PRODUCT CHANGE NOTIFICATION

Select Bourns® Model SRU1048 Series Shielded SMD Power Inductors

Change to Inductor Shield Design

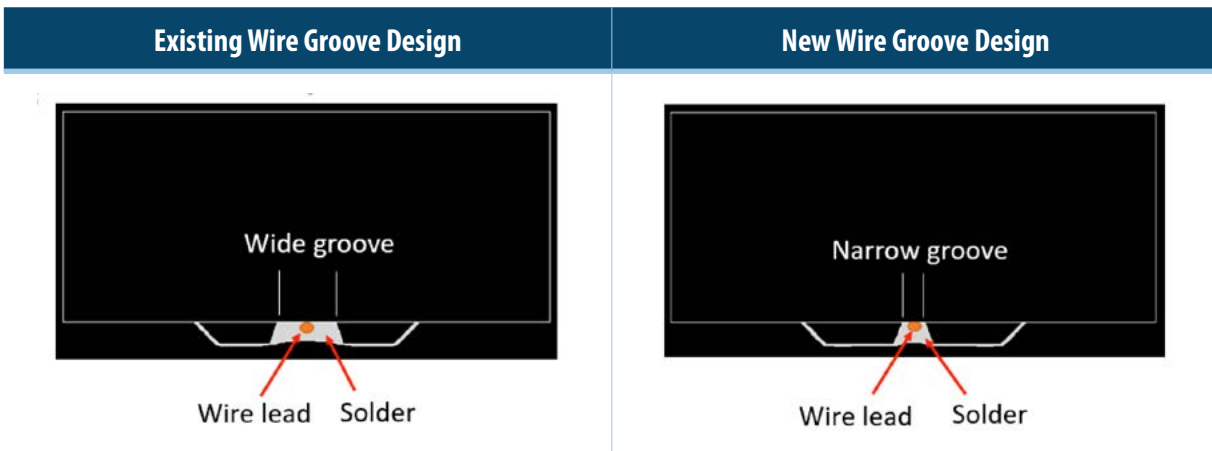
Riverside, California – July 21, 2021 – Effective January 15, 2022, Bourns will change the inductor ferrite shield design for select [Model SRU1048 Series Shielded SMD Power Inductors](#). The wire groove of the modified ferrite shield will be narrowed which will result in a better fitting for the wire lead.

The form of the inductor will change because of the narrower wire groove. The fit and function of the inductor will remain the same. The quality and reliability of the component should be improved.
